TEAC TECHNICAL INFORMATION

TASCAM SX-1/DM-24, Change of Capacitors on SW PSU

No. **0304R**
DATE 04th Mar 2003

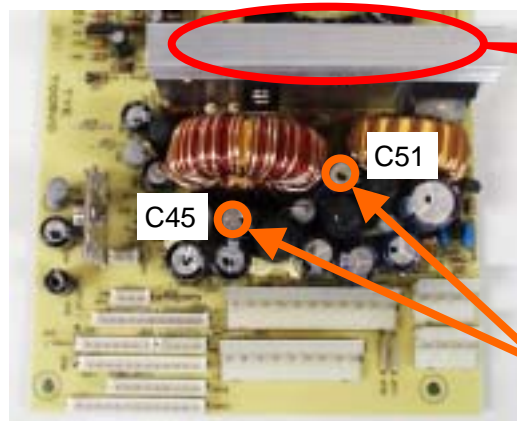
There is no print of the P/N etc anywhere on the former SW PSU but the new PSU can be identified by "01" or "02" mark stamped on the top of a heat sink as following picture. "01" means reworked SW PSU of TTC stock. "02" means the new SW PSU supplied from original manufacture.

* Early reworked SW PSU has no "01" or "02" mark. A sign of rework can be identified in case the C45 and C51 have an orange color sleeve fitted.
